REMARKS

Claims 1 through 72 are pending in the application. Claims 1, 5 through 10, 14 through 19, 23 through 27, 38, 49 and 60 have been amended. Claims 70 through 72 are newly added. Reconsideration of this application is respectfully requested.

FIG. 11

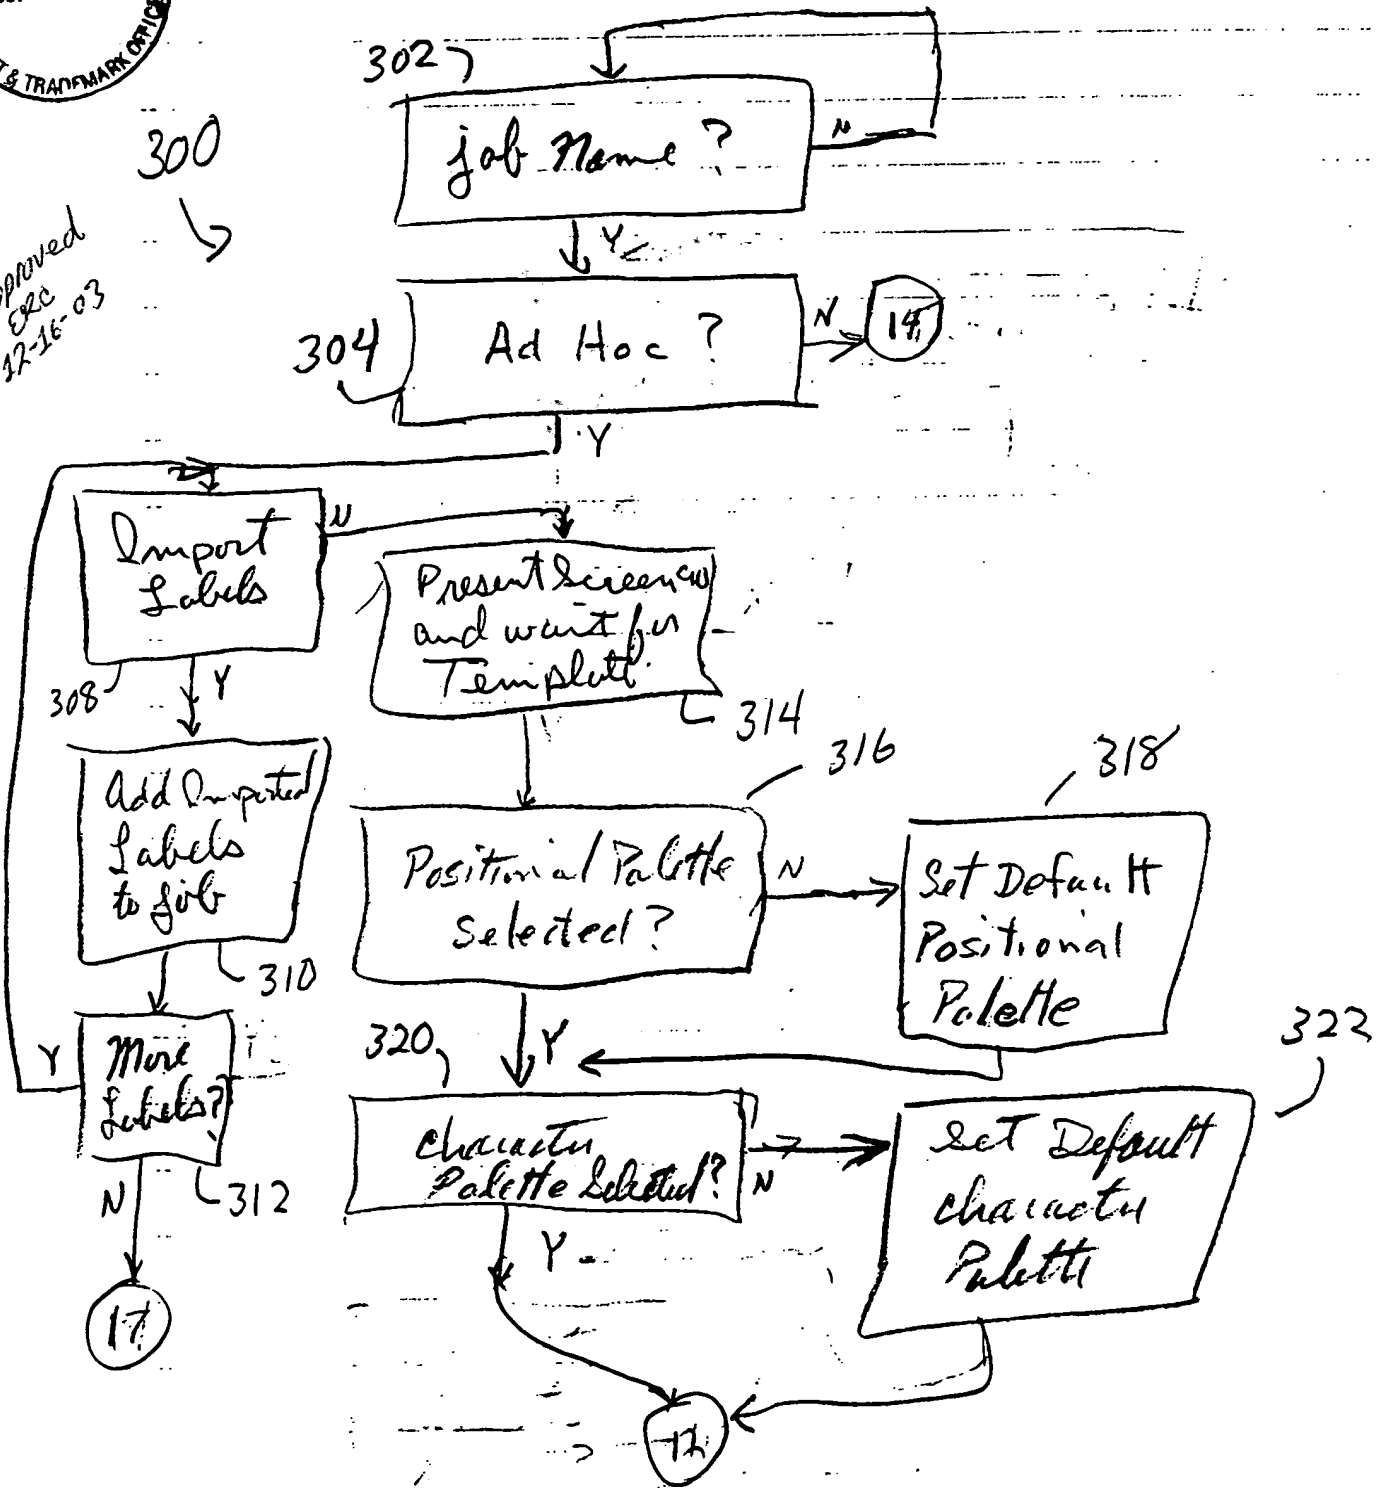
The Office Action has objected to the drawing on the ground that Figs. 11, 12, 13 and 17 lack certain Y or N legends as detailed at pages 2 and 3 of the Office Action. Replacement drawing sheets containing proposed revisions to Figs. 11, 12, and 17 are attached hereto for the Examiner's approval. Thus, Fig. 11 has been amended by supplying a "Y" for step 304. Fig. 12 has been amended by supplying "Y" and "N" legends for step 342. Fig. 17 has been amended by supplying "Y" legends for steps 452 and 464.

FIG. 16

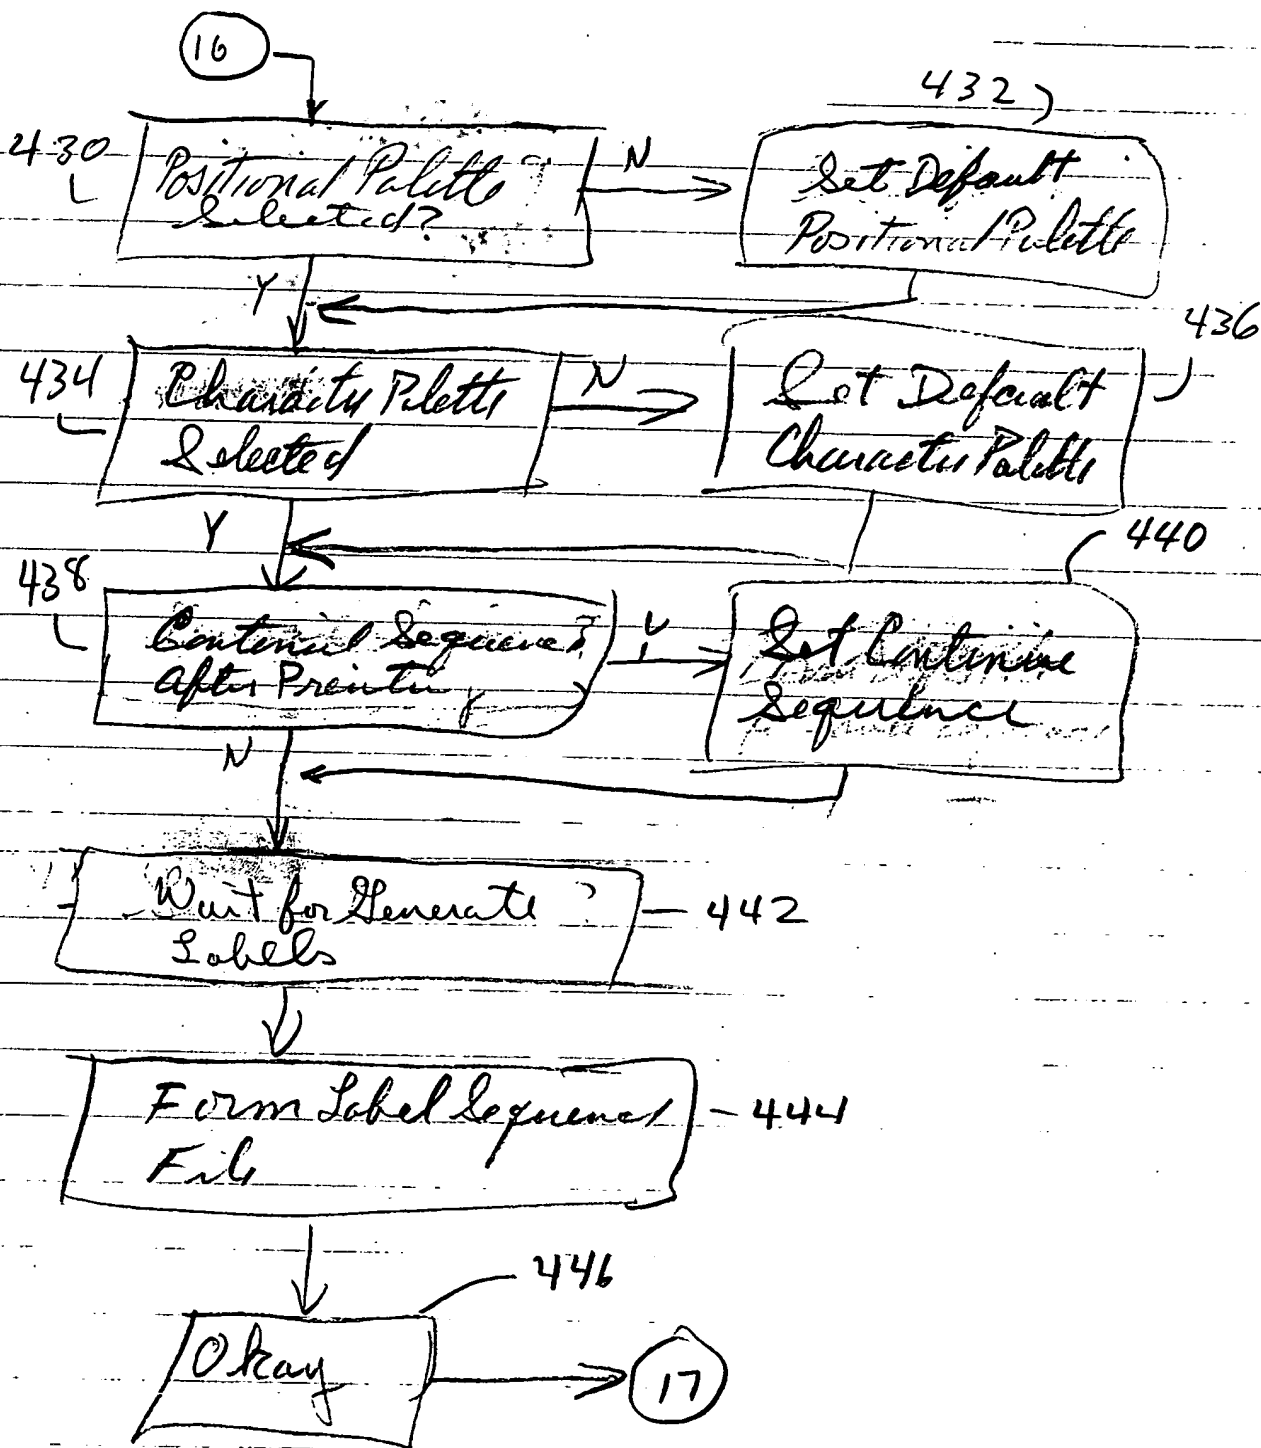
With respect to the objection to Fig. 16, the specification has been amended at page 16 to provide a description that is consistent with Fig. 16. A replacement drawing sheet is also attached that contains a proposed revision to Fig. 16 for the approval of the Examiner. Fig. 16 has been amended to change step 432 to read "Set Default Positional Palette" in stead of "Record Selected Positional Palette". Support for this change is found in the original specification at page 16, line 6. Fig. 16 has also been amended to add a "Y" legend at step 434 and to delete a "Y" legend at step 442.
